Type of Submission: Notice of Intent	Type of Action: Plug and Abandonment
Date Sundry Submitted: 03/14/2024	Time Sundry Submitted: 12:06
Date proposed operation will begin: 04/01/2024

HILCORP ENERGY COMPANY
SAN JUAN 22
P&A NOI

CONDITIONS OF APPROVAL

BLM - FFO - Geologic Report

SAN JUAN 22 - PROPOSED WELLBORE SCHEMATIC

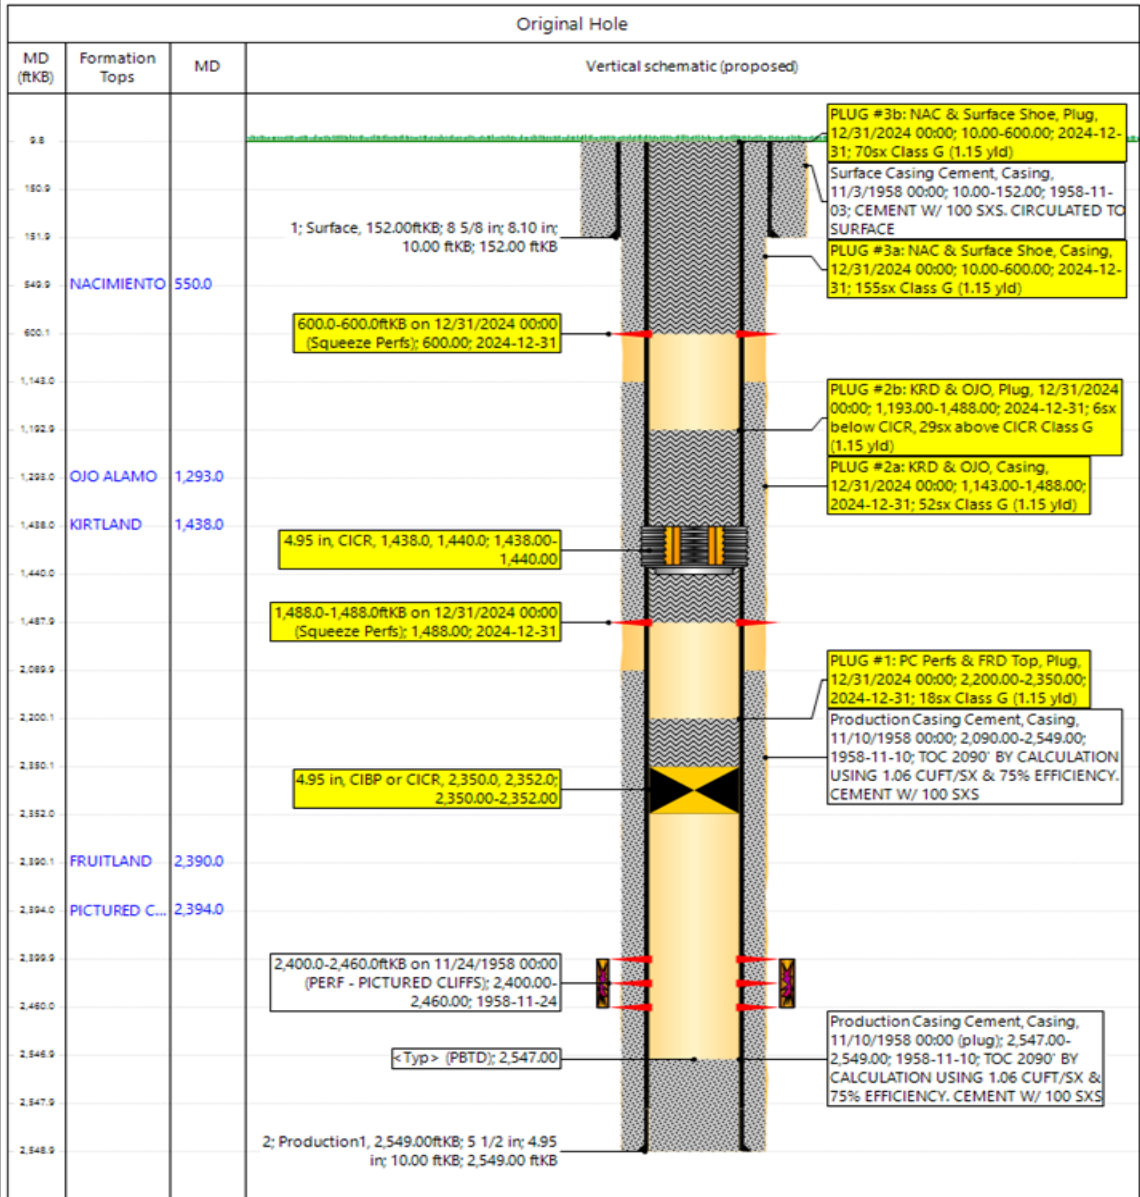
1. Plugging operations authorized are subject to the attached "General Requirements for Permanent Abandonment of Wells on Federal and Indian Lease."
2. The following modifications to your plugging program are to be made:
 - a. Adjust the top of Plug 1 to 1926 ft to account for the BLM geologist's Fruitland top at 2026 ft.
 - b. Adjust the top of Plug 2 to 1026 ft to account for the BLM geologist's Ojo Alamo top 1126 ft.
3. Farmington Office is to be notified at least 24 hours before the plugging operations commence at (505) 564-7750.

-Vertical wellbore, all formation depths are TVD from KB at the wellhead.
-Adjust the top of Plug 1 to 1926' to account for the BLM geologist's Fruitland top.
-Adjust the top of Plug 2 to 1026' to account for the BLM geologist's Ojo Alamo top.
-The surface formation is the Nacimiento, therefore the bottom of Plug 3 may be adjusted.

Created By	Condition	Condition Date
mkuehling	Follow BLM tops - start plug 1 50 feet below pc top - Notify NMOCD 24 hours prior to moving on - Monitor string pressures daily report findings in subsequent.	3/14/2024
